ADDENDUM NO. 4

04/15/2026

YWCA OF GRAND ISLAND WYANDOTTE RENOVATION

315 WYANDOTTE ST

1 FIRST FLOOR - SANITARY PLAN
1/8" = 1'-0"

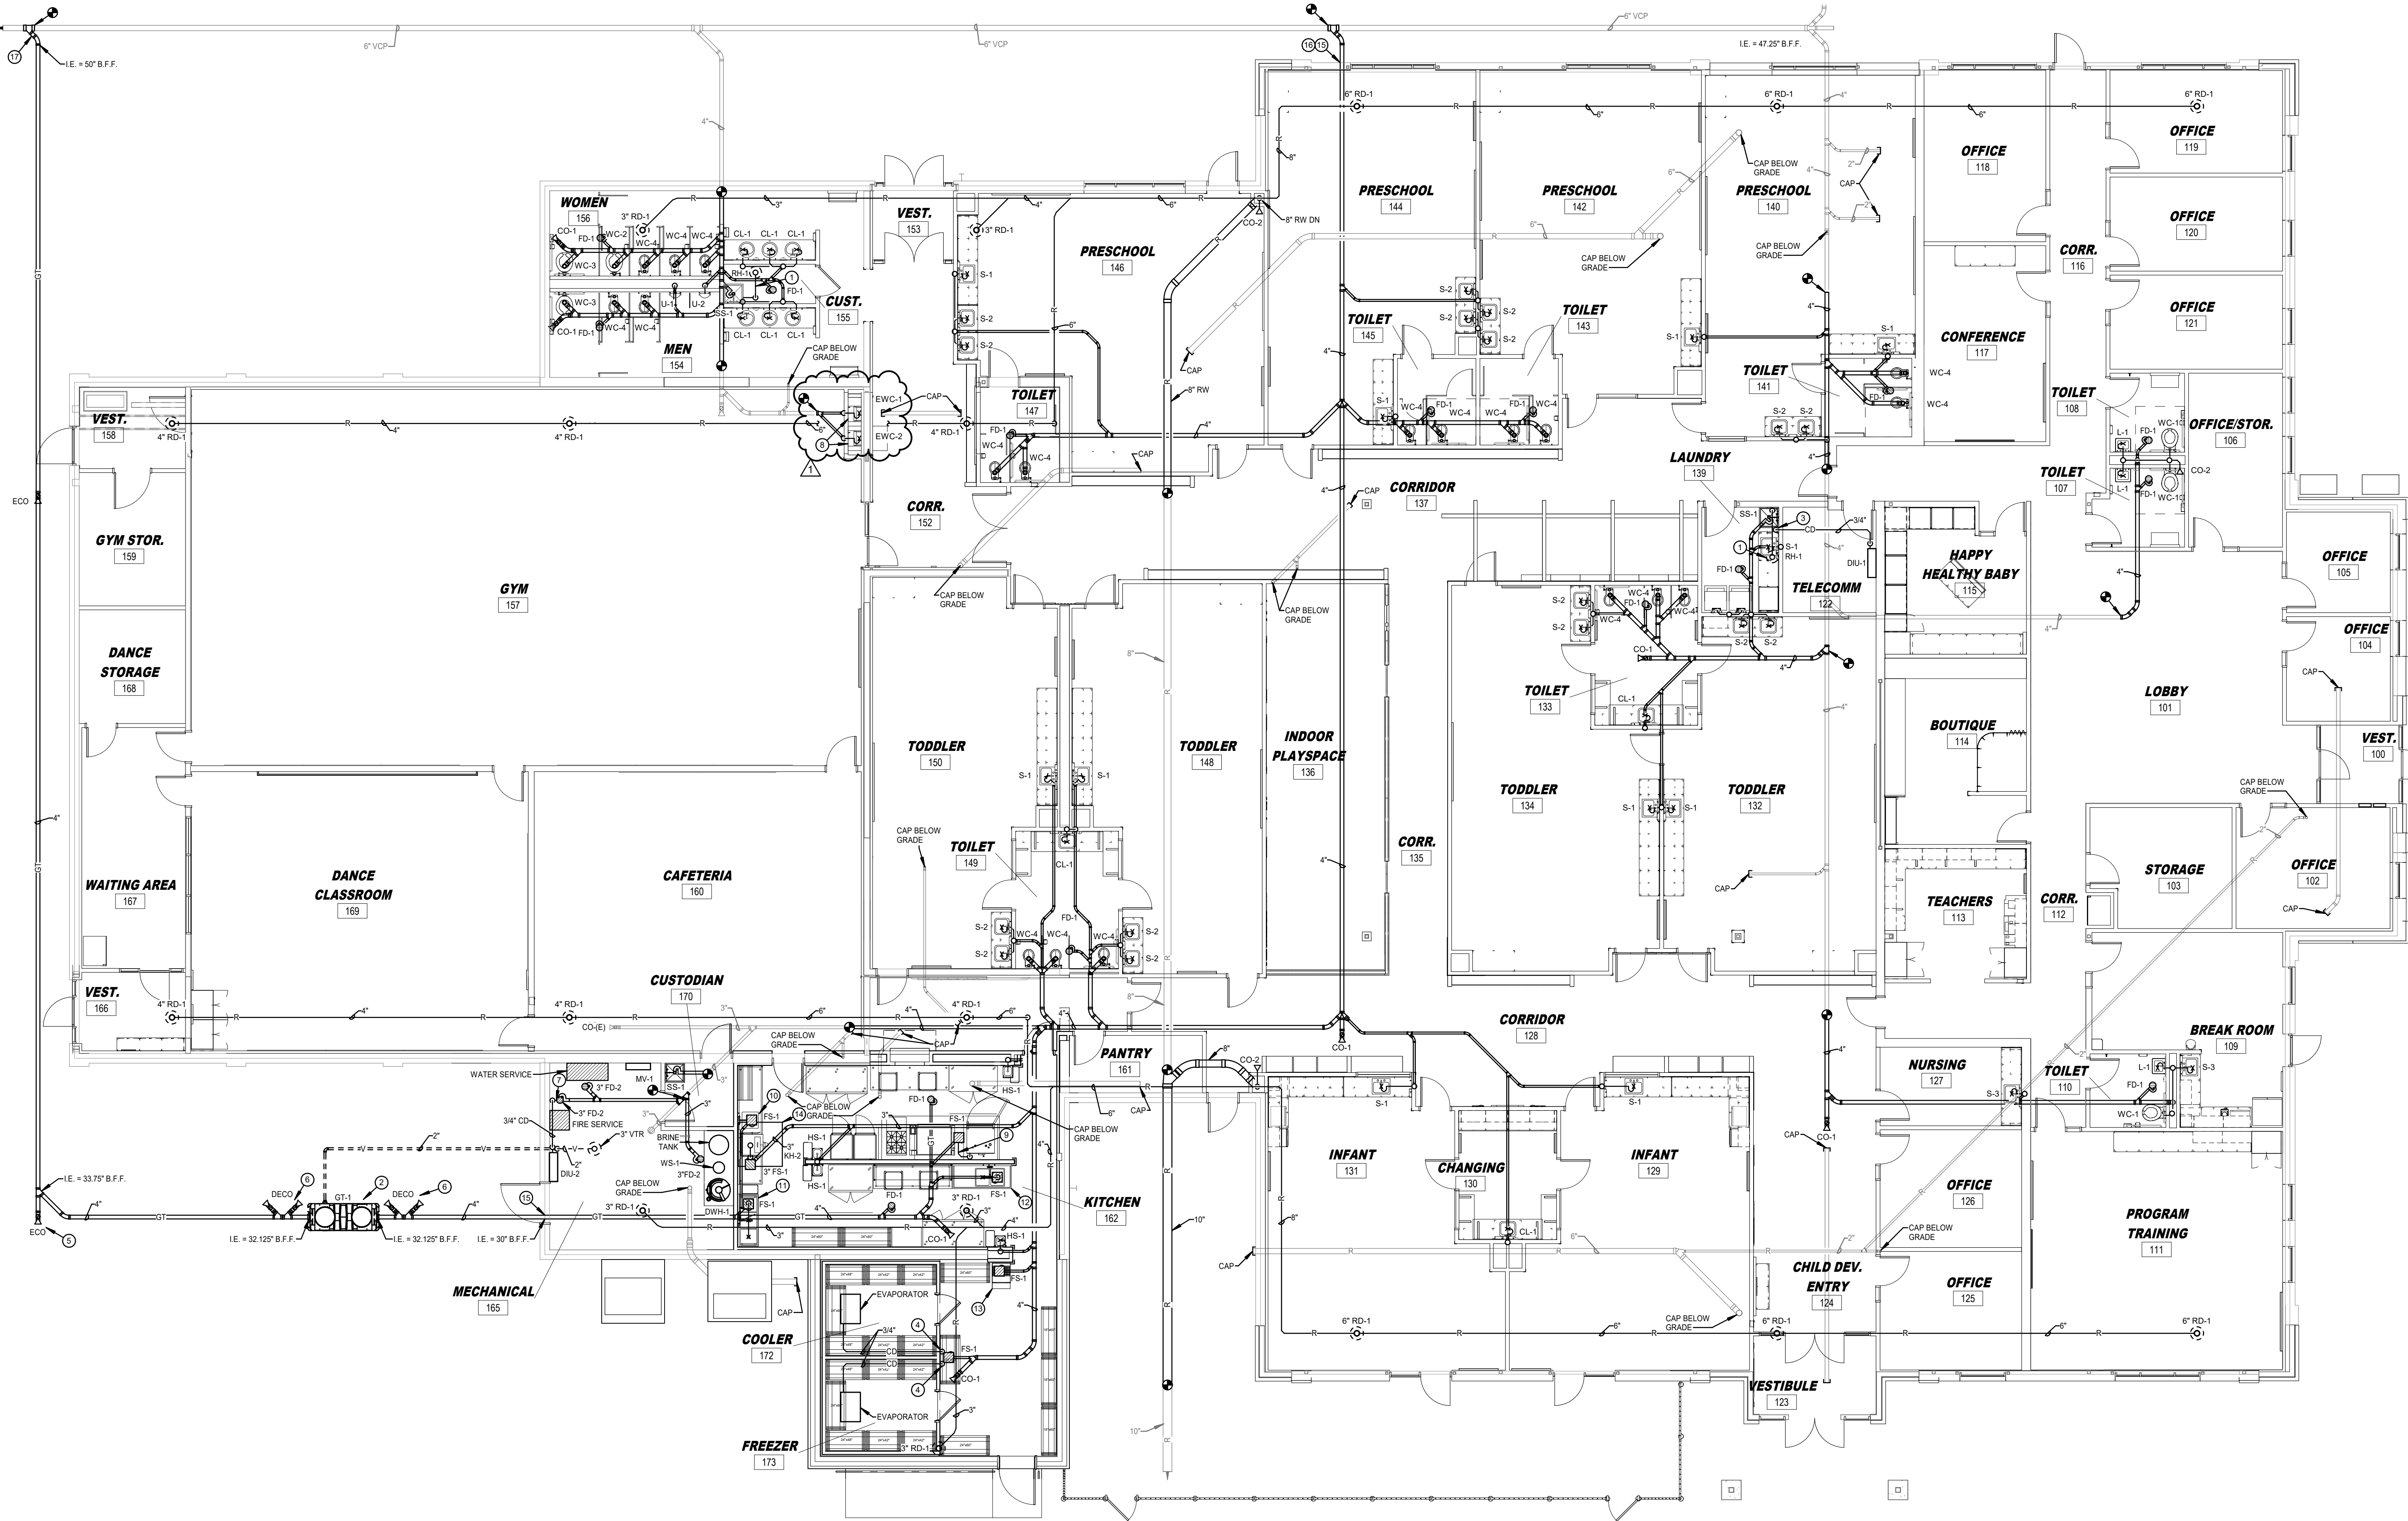
2. Sheet M1.00 First Floor – Sanitary Plan
 - a. See sheet M1.00 for changes to electric water cooler (EWC-1) to electric water cooler (EWC-2).
 - b. See sheet M1.00 for changes to sheet note #8.

SHEET
M6.00

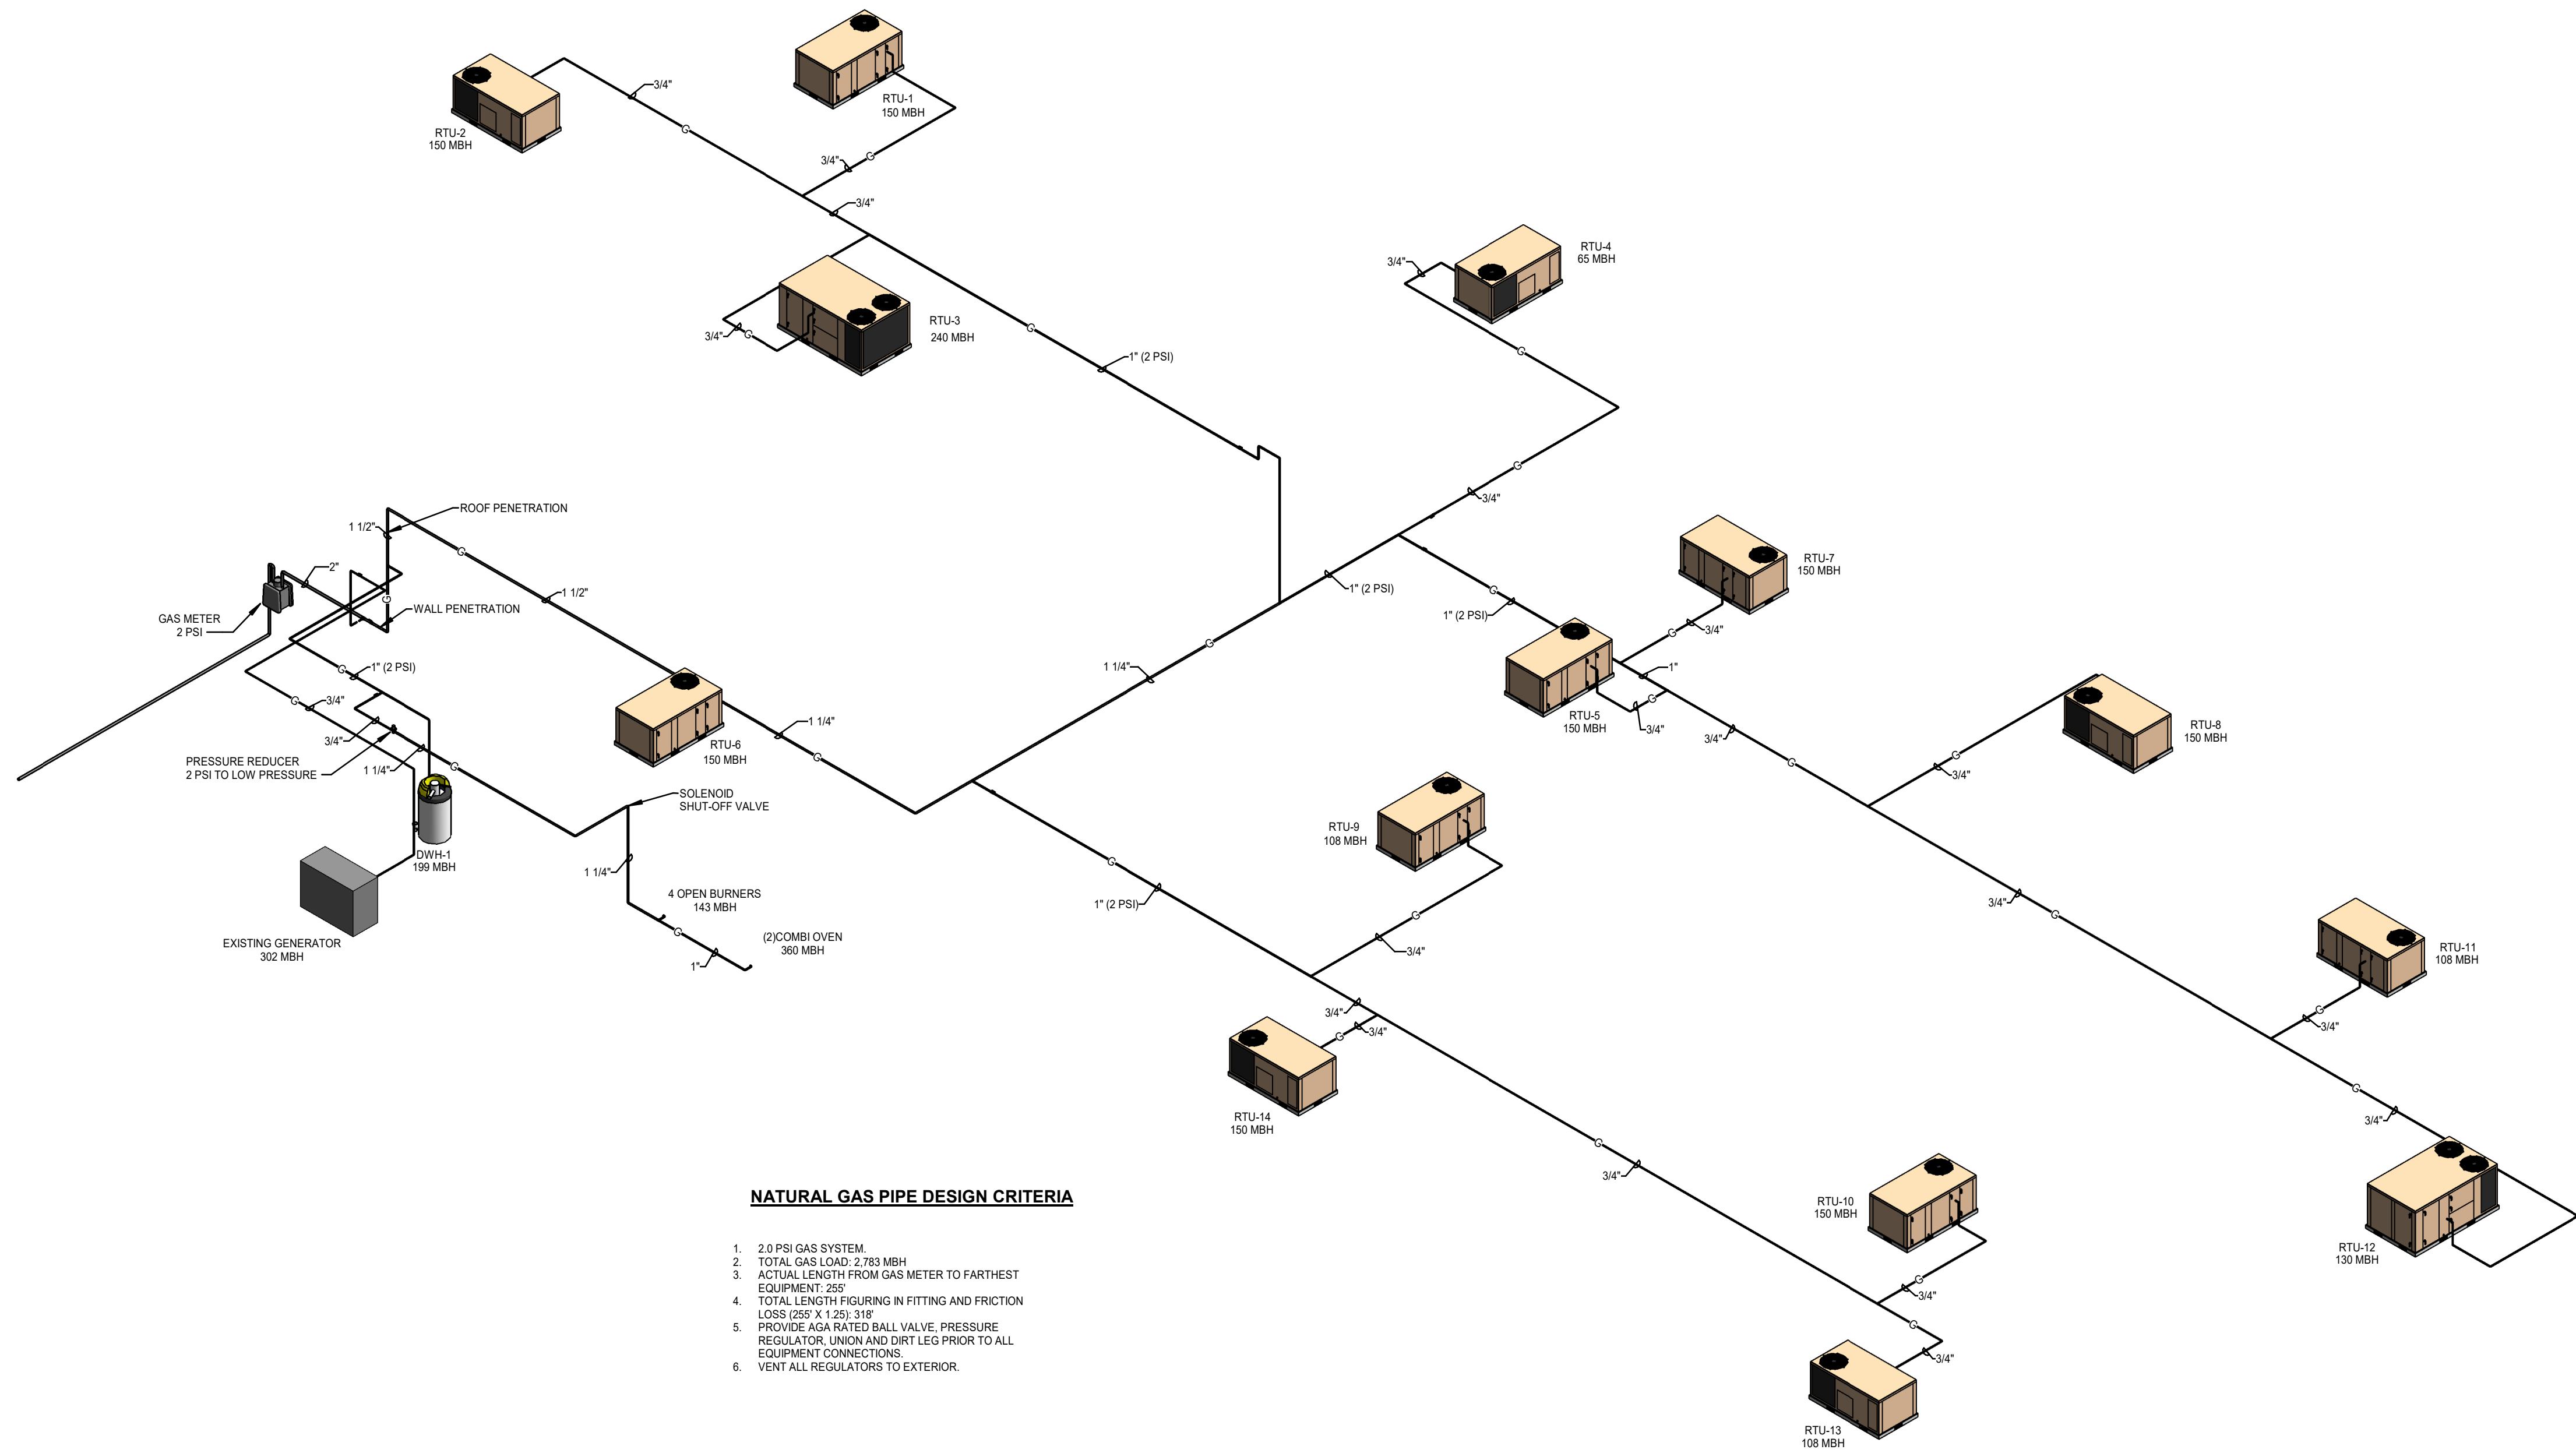
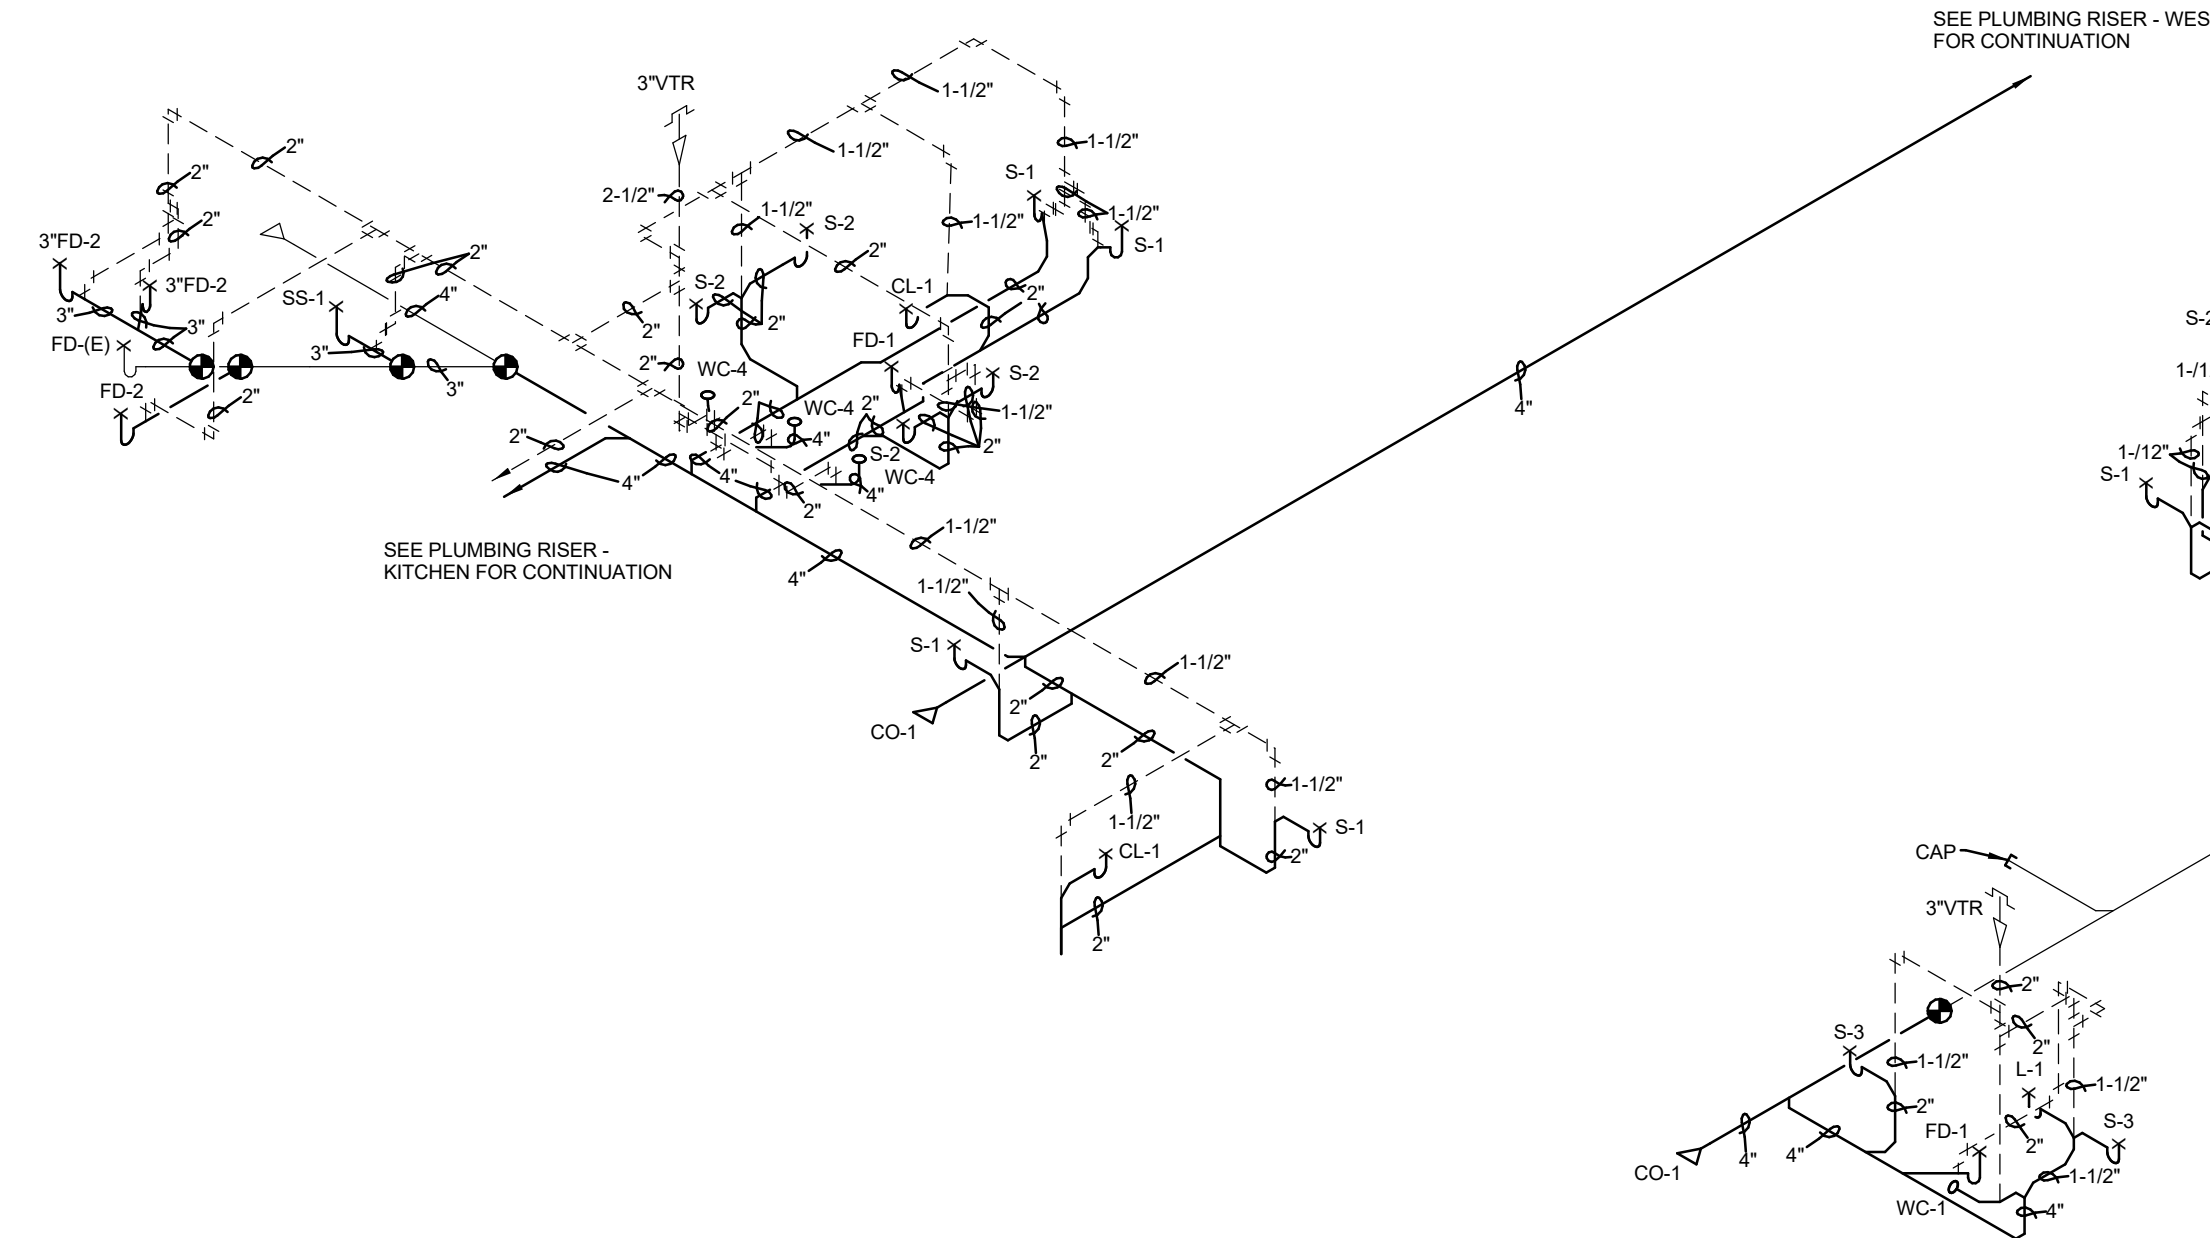
5. Sheet M6.00 Mechanical Risers
 - a. See sheet M6.00 for changes to Plumbing Riser – Mens 154 / Womens 165.
